### Introduction

**Detailed comments on scheme as proposed in consultation.**

NOTE 1: Comments are mainly based on TRO drawings. Landscape drawings have generally been used to show locations.

9 Sheet 9 Foot of the Walk to Jane St

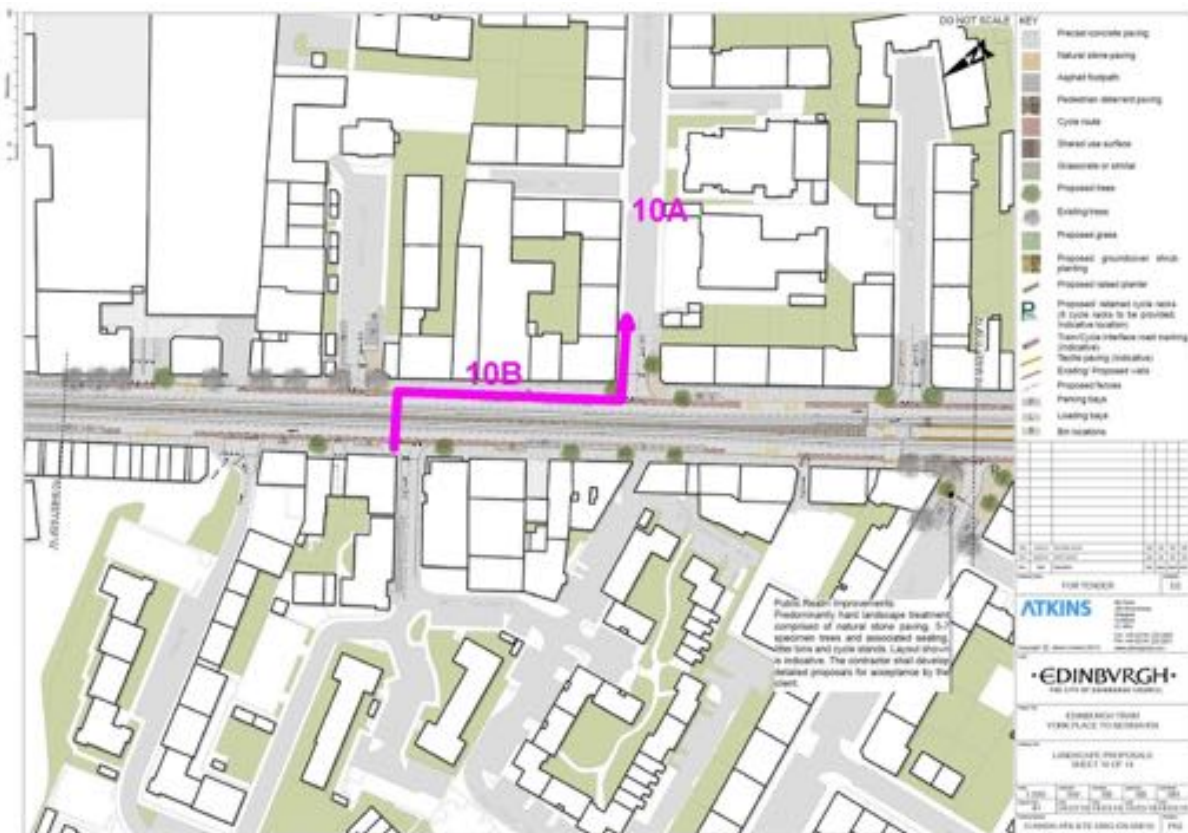
9A Spokes proposes (see 8A) that the tram stop is moved from Constitution Street to the Foot of the Walk (indicative location shown) and cycling infrastructure be provided on Constitution Street.

9B Tram tracks too close to kerb - no room for cyclists turning left from Duke Street.

9C Safe cycle crossings need to be provided at the junction of Leith Walk with Great Junction and Duke Streets. 2-stage crossings should be considered for some turns.

There is an awkward angle for cyclists turning right from Leith Walk across the tracks into Duke Street - especially if the tracks are slewed enough to allow room for cyclists turning left from Duke Street into Leith Walk.

9D Dual one-way segregated cycleways should be provided for the length of Leith Walk. Parking/loading in on-road cycle lanes on Leith Walk render them unusable for cyclists of all ages and abilities and will force cyclists too close to the tram lines. **This layout is building in very severe danger - the Council is fully aware that many tramline cycle crashes occur when a cyclist wishing to travel parallel to the lines is forced into them by traffic pressures, such as vehicles moving out from the kerb.** The proposals are a significant reduction in the quality of the existing cycling facilities and public realm. Space could be provided by retaining the existing 2 traffic lanes and not increasing to 4 lanes as proposed. Additional space could be taken from the gardens on the West side (9F) that are used for storing bins - this may also free up space for the relocated tram-stop. Further space would also come from removing the median strip (9G). (See Area-wide comments A2 Leith Walk)

9E Consideration should be given to implementing some segregated cycleways on Great Junction Street, at least as far and connecting to Henderson Street, for access through to The Shore and other destinations to the North.

10 Sheet 10 Leith Walk to Balfour Street and tram-stop

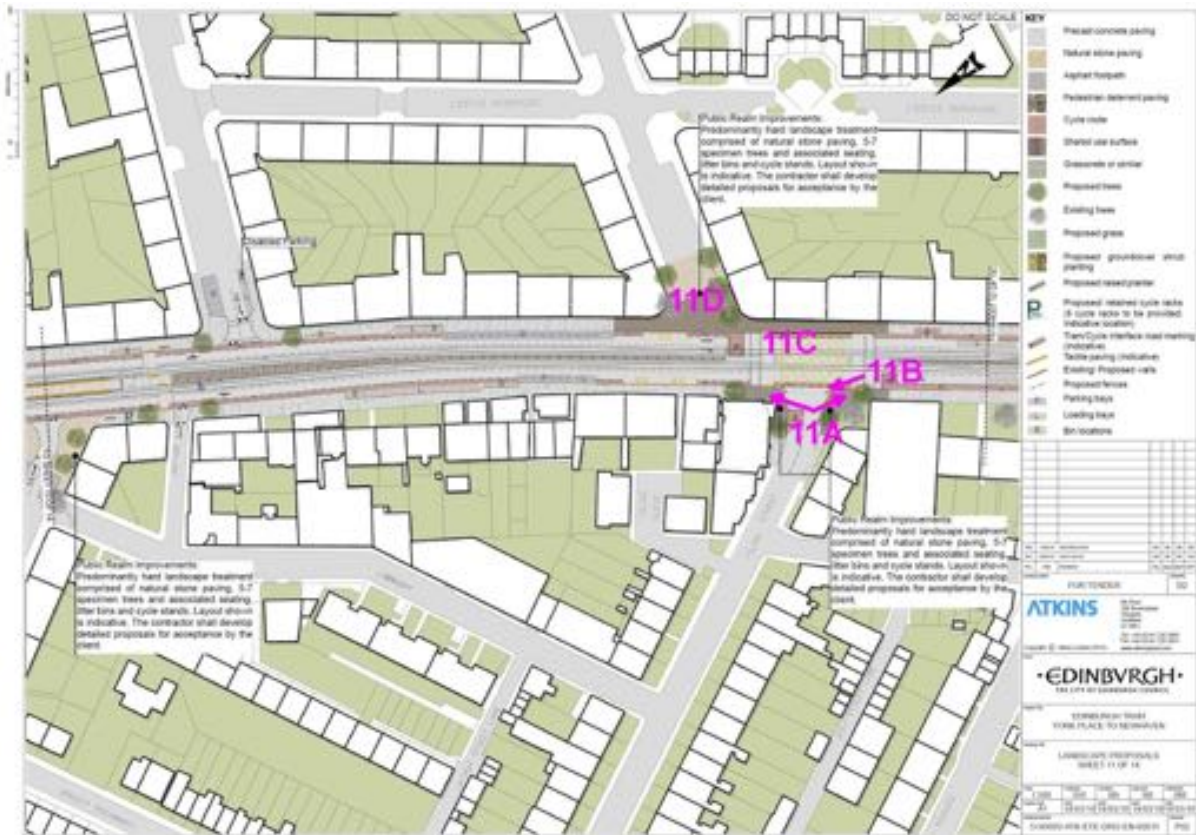
10A Lorne Street could be truncated/ made non-permeable to through motor traffic.

10B The area should be permeable to people on bikes, with connections between streets on the West and East sides of the Walk (eg Steads Place to Lorne Street), incorporating safe crossings of the tram tracks. The current proposals would make it impossible to cycle from the city centre via Leith Walk to any of the east-side streets north of Brunswick Road.

11 Sheet 11

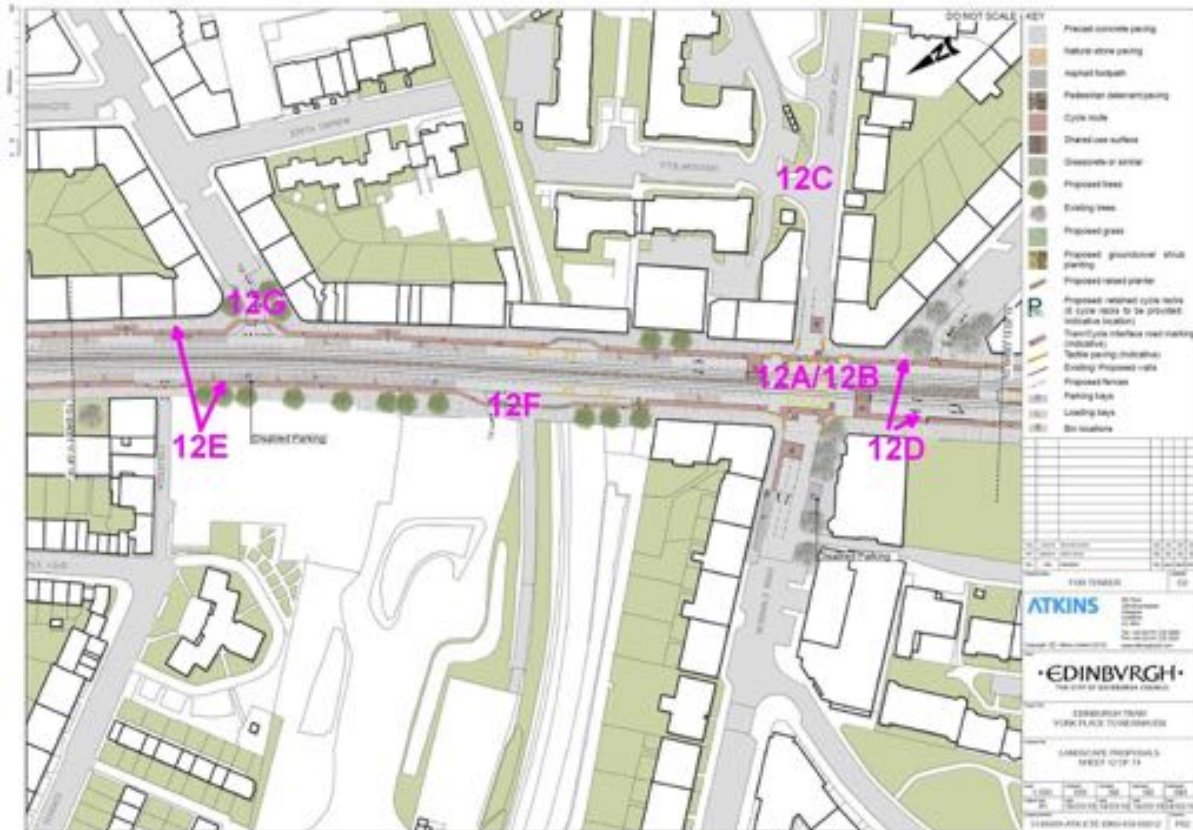
11A Shared space at the sides of Pilrig Street will cause conflict between cyclists and pedestrians

11B Drivers tend to cut the corner when turning left into Pilrig Street, endangering cyclists making the same manoeuvre. Cyclists turning left into Pilrig Street need protection (eg a kerb) from vehicles cutting the corner. Consideration needs to be given to reducing this danger by adjusting corner radii, physical protection or other methods as appropriate.

11C 2-stage right turns are needed to allow cyclists to turn right across the tracks safely. This should include the ability for cyclists to turn into Iona Street from Leith Walk (South) without needing to use shared space. (This should negate the need for the problematic shared space in 11A.)

11D Shared space on the Leith Walk pavements either side of Iona Street will cause conflict. All that is needed is a cycle entrance into Iona Street and the rest left as footway (like the "existing" arrangement, but without the car exit).

12 Sheet 12 Leith Walk to Brunswick Street

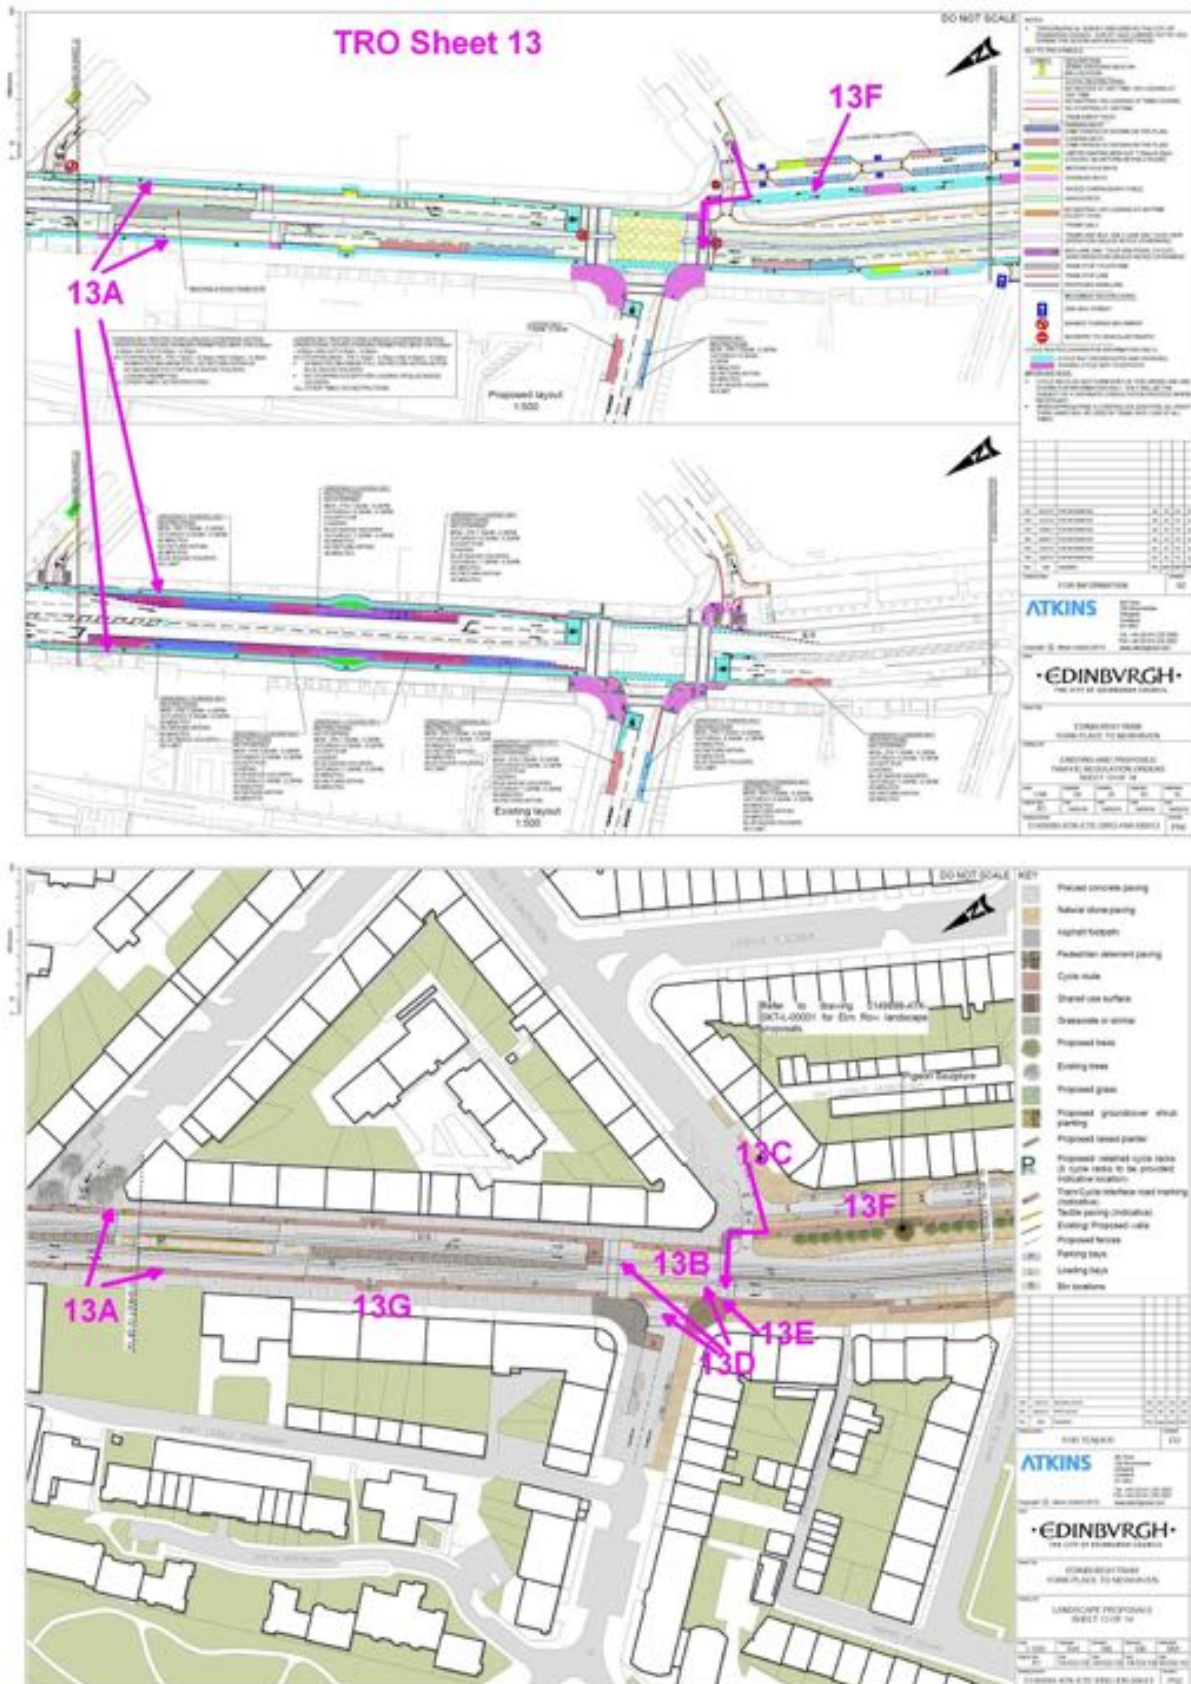
12A 2-stage turn cycle waiting areas need enlarging, repositioning into or closer to the cycle lanes on Leith Walk and surface signage is needed to lead cyclists into them, particularly those on Leith Walk. The left turn cycle lanes should be kerb-protected rather than just surface-coloured.

12B Advanced release timings should be extended (5 seconds rather than 3?)

12C Brunswick Road forms part of cycling Quiet Route 20. Measures need to be taken to protect this as a quiet route and to avoid the risk of rat running by traffic from the East as this is the only right turn onto Leith Walk from that direction if the London Road right turn is banned as proposed (see 14F).

12D The new cycleways to the South should be at-grade and kerb-separated from the footways and 500mm from the carriageways.

12E Tactile separation of pavement cycleway is not adequate and should be replaced with height and kerb separation from footway and min 500mm safety strip from road.

12F The design of the floating bus stop shelter and its display panels is not optimal. People queue across the cycleway and display panels obscure the view of approaching cyclists from pedestrians (and vice versa).

12G At Albert Street, the cycle crossing is not set far enough back for large vehicles turning into Albert Street to stop without blocking Leith Walk. Consider setting the crossing further in or providing for vehicles to stop on Leith Walk. Cyclists seem nervous to use the crossing as it stands and sight lines, surface indications/driver warnings should be investigated to ensure that cyclists have and are given priority.

13 Sheet 13 Leith Walk to Montgomery Street

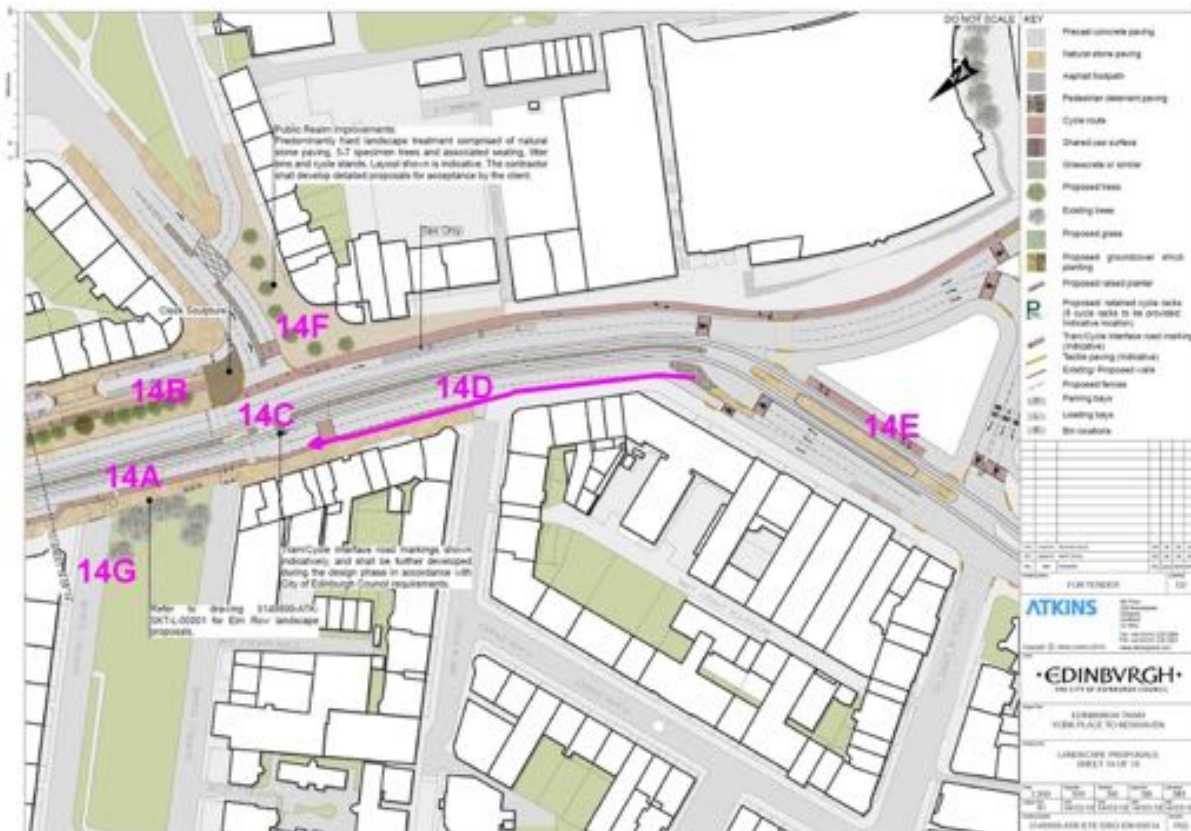
13A TRO Sheet 13 “existing layout” does not show what is currently on the ground, but may be what the Leith Walk Phase Programme had proposed. There is currently no cycling provision in this area. The “proposed cycle lanes” should be at-grade,

13B The Annandale Street junction design seems to continue the Leith Walk Programme proposals and it appears that the cycleways on Leith Walk are on the pavement and that cyclists will need to cycle on the pavement in order to make 2-stage turns at the junction. The cycleways should be instead be treated as being part of the road, though kerb-separated, and cyclists should have separate space for crossing without needing to use shared pavement, similar to the junction arrangement at McDonald Road.

13C There is a convoluted, seemingly conflicting and unprotected route proposed for cyclists crossing from Montgomery Street to Annandale Street/Leith Walk. This needs to be redesigned to solve these problems.

13D Cycle crossings should generally be on the inside of the junction and pedestrians to the outside, the opposite of what is shown.

13F Spokes believes that the 2-way segregated cycleway from Leith Street/Picardy Place should become 1-way segregated cycleways as early as possible - probably at the London Road junction. Spokes does support the continuation of the 2-way cycleway from Leith Street/Picardy Place as far as Montgomery Street, but this must be in addition to a northbound segregated on-road cycleway from London Road. We are not supportive of the place-making proposals and feel that a more appropriate design should be sought that retains the cycleway (See comments on Sheet14.)

13G The cycleway makes difficult 90-degree turns around this bin. We assume that this won't be the case in practice, particularly given our proposal for redesigned kerb-separated cycleways..
